TAS5508B Errata

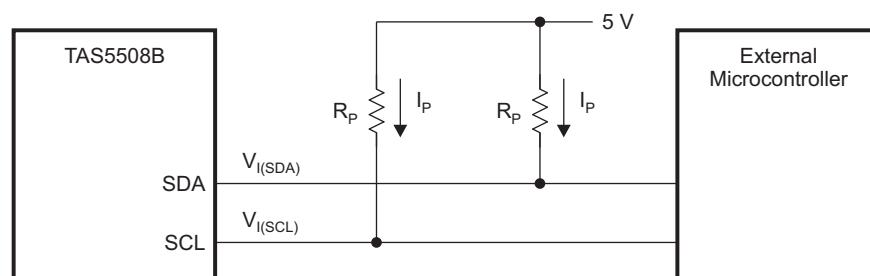
In systems using 5-V CMOS buffers for the I²C interface, special pullup resistors are required.

The I²C specification requires that V_{IH} is $0.7 \times V_{DD} = 3.5$ V when V_{DD} is 5 V. In some 5-V CMOS systems, the normal value for the I²C pullup resistor is 4.7 k Ω . This could cause the voltage not to rise above 3.47 V, which violates the specification. The root cause has been identified as a TAS5508B 5-V tolerant buffer issue.

It is recommended that the I²C pullup resistors, R_P , be 3.3 k Ω (see [Figure 1](#)). If a series resistor is in the circuit (see [Figure 2](#)), then the series resistors, R_S , should be less than or equal to 300 Ω .

(1) $V_S = 5 \times R_S / (R_S + R_P)$. When driven low, $V_S \ll V_{IL}$ requirements.

(2) $R_S \leq 300 \Omega$

M0012-01

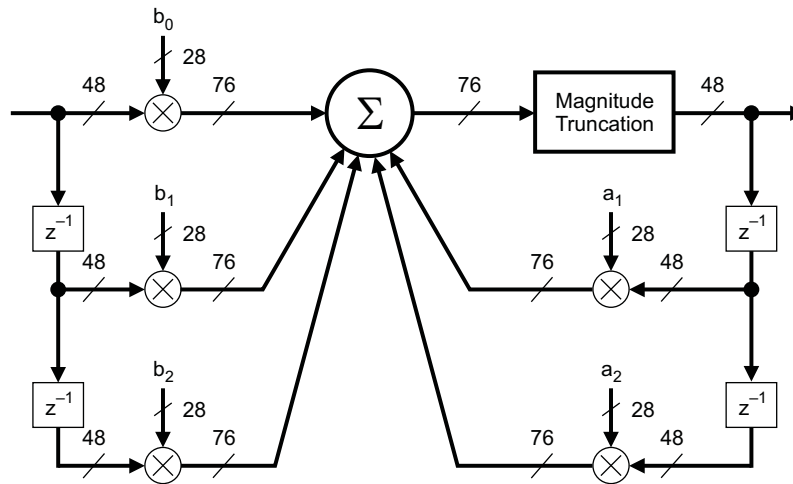
The TAS5508B exhibits a one-sample delay on channels 1, 2, 5, and 6 for sample rates of 32, 44.1, and 48 kHz. The delay occurs in the PWM section.

This time misalignment can impact applications where the TAS5508B is used to provide crossover filtering and bi-amplification, as in powered loudspeakers. The problem that occurs in these cases is that a one-sample time delay in either the high-pass or low-pass path causes an error in the overall crossover frequency response.

The time misalignment can be corrected by using a biquad to provide a one-sample delay for each of the nondelayed PWM channels for the 48-, 44.1-, and 32-kHz sample rates.

When the 8×2 crossbar mixer provides a 1:1 input-to-output connection, an eight-channel loudspeaker configuration uses one of the seven biquads in channels 3, 4, 7, and 8 to provide a one-sample delay.

1. Set the b1 biquad coefficients to a gain of 1.
2. Set all of the other biquad coefficients (b0, b2, a1, and a2) to a gain of 0, as shown in the following diagram and table.
